**CITY OF DULUTH**

**STAFF REPORT**

<b>File Number</b>	PL 14-035	<b>Contact</b>	Jenn Reed Moses, jmoses@duluthmn.gov	
<b>Application Type</b>	Variance	<b>Planning Commission Date</b>	May 13, 2014	
<b>Deadline for Action</b>	<b>Application Date</b>	April 8, 2014	<b>60 Days</b>	June 7, 2014
	<b>Date Extension Letter Mailed</b>	April 22, 2014	<b>120 Days</b>	August 6, 2014
<b>Location of Subject</b>	3635 Lake Ave S			
<b>Applicant</b>	Robert and Carole Lent	<b>Contact</b>	218-727-1743; lent777@charter.net	
<b>Agent</b>		<b>Contact</b>		
<b>Legal Description</b>	010-3100-01860 and 010-3100-01870			
<b>Site Visit Date</b>	May 7, 2014	<b>Sign Notice Date</b>	April 29, 2014	
<b>Neighbor Letter Date</b>	April 24, 2014	<b>Number of Letters Sent</b>	23

Applicants are proposing a 500 square foot addition that would require a variance from the front yard setback (19 feet instead of 25 feet from 37th Street).

**Lent residence**  
3635 South Lake Avenue  
Duluth, MN

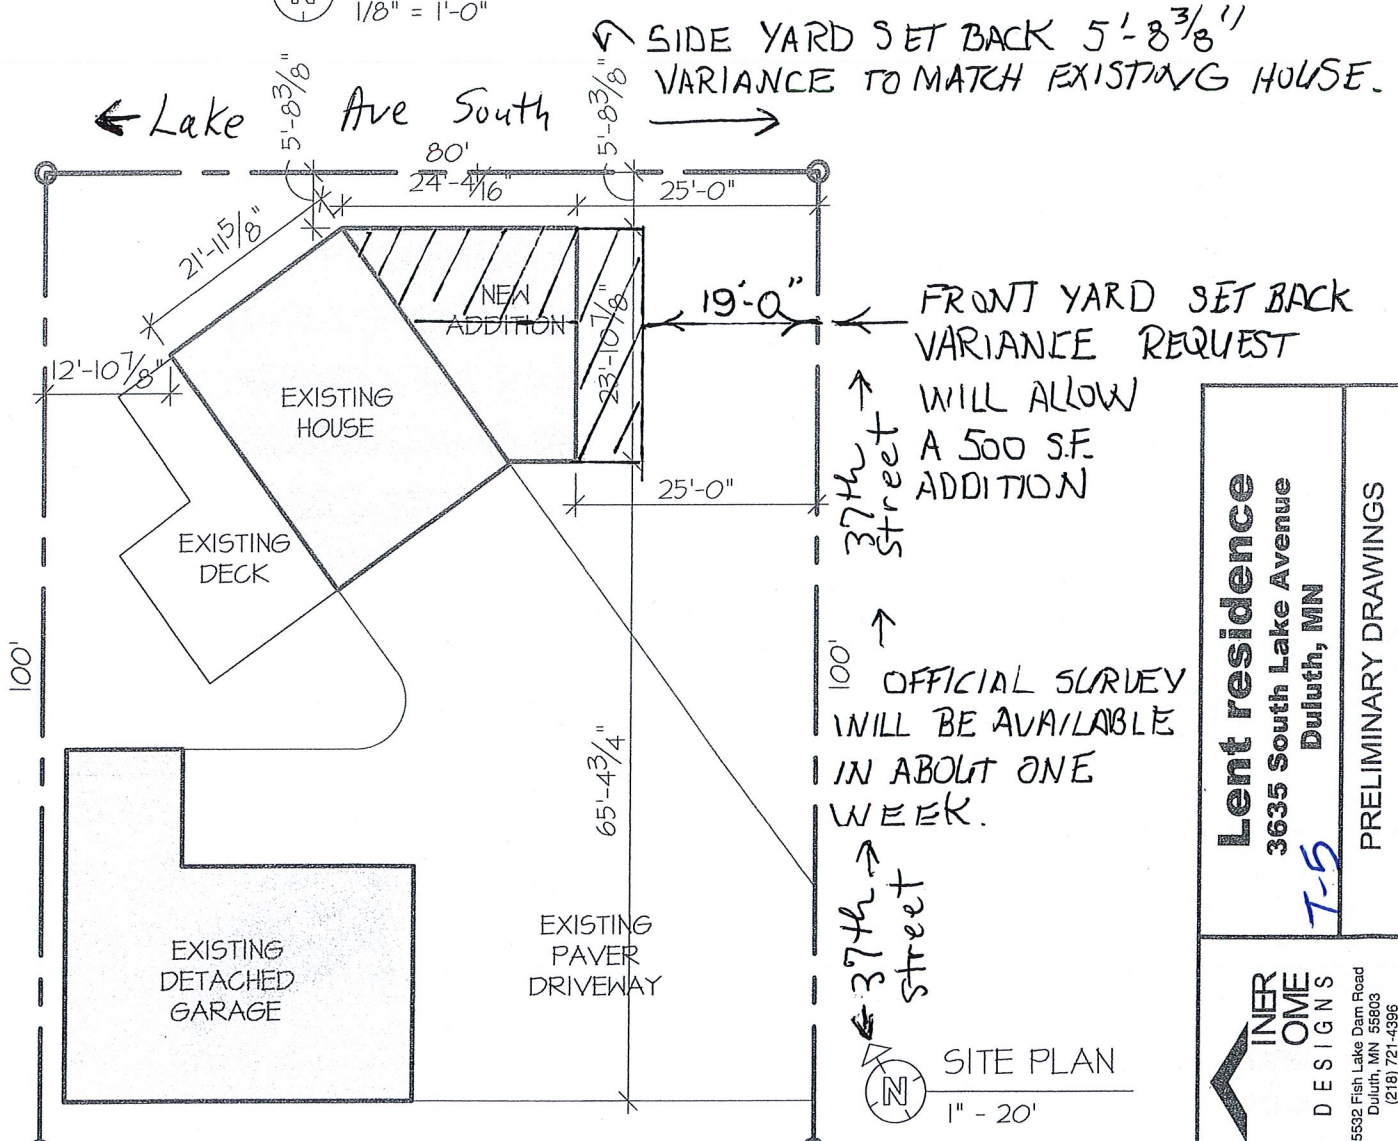
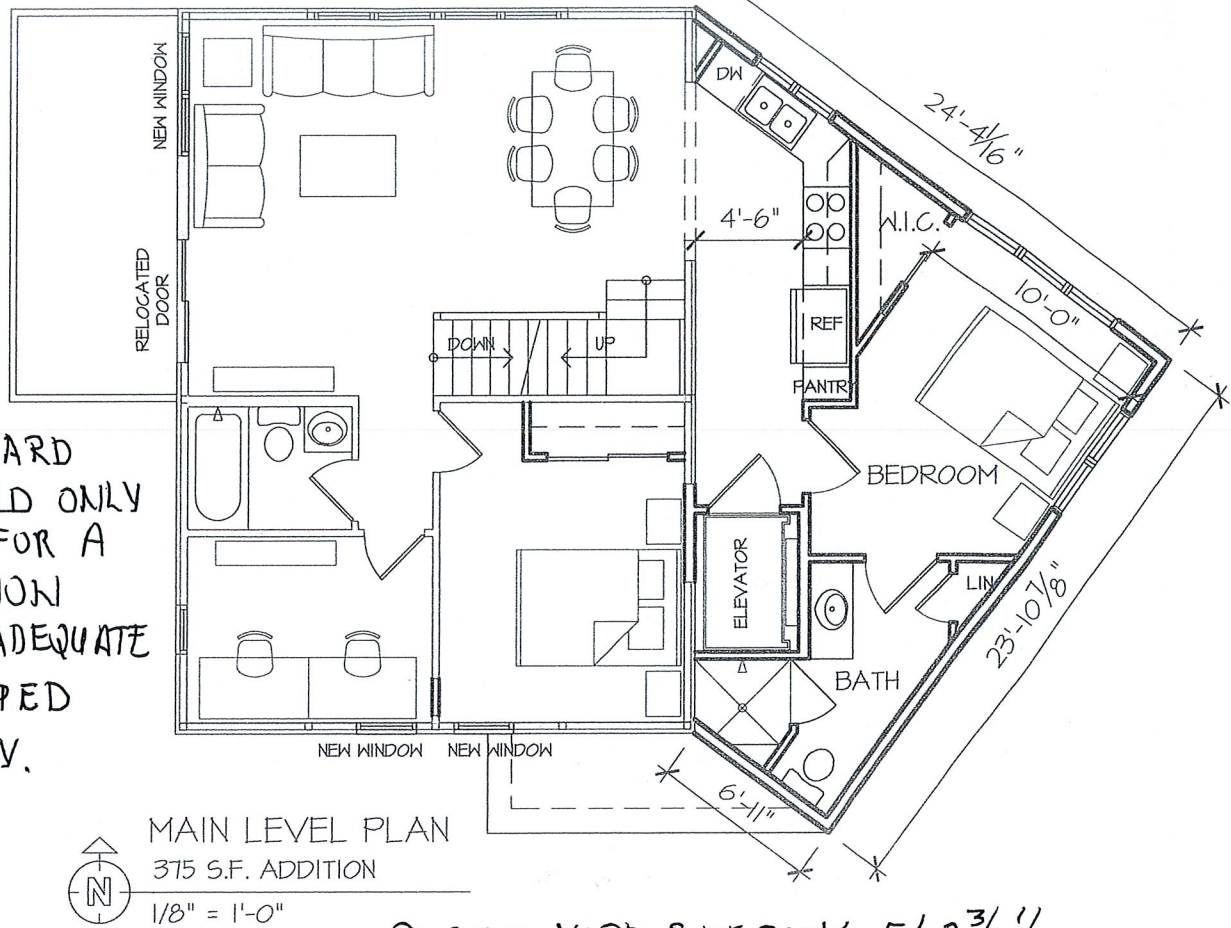
- 3.) House is currently almost 32' from front property line (37th Street). Applicants are requesting a variance to the front setback to build an addition 19' from the property line.

- 5.) Request for variance is not due to exceptional narrowness, shallowness, or shape of the applicant's properties. The relief is not necessary for the preservation and enjoyment of a substantial property right. Although applicant wishes to add handicapped accessible features to the home, there is no need for accessibility for the current occupants. In addition, Staff believes that a handicapped accessible bedroom and bathroom could fit into the space currently occupied by the existing bedroom, bathroom, and office, thereby minimizing the need for a variance. Although applicant states the need for a caretaker bedroom, this need is not demonstrated at this time; if the need arises, a bedroom on another floor of the house could be used as a caretaker bedroom.

- 1.) Request for variance is not due to exceptional narrowness, shallowness, or shape of the applicant's properties.
- 2.) The relief is not necessary for the preservation and enjoyment of a substantial property right.
- 3.) Applicants do not demonstrate need for handicapped accessibility at this time and thus do not have practical difficulty.
- 4.) Reason for request is to serve as a convenience to the applicant.
- 5.) Applicant has not demonstrated practical difficulty.

Based on the above findings, Staff recommends that Planning Commission deny the variance, for the following reasons:
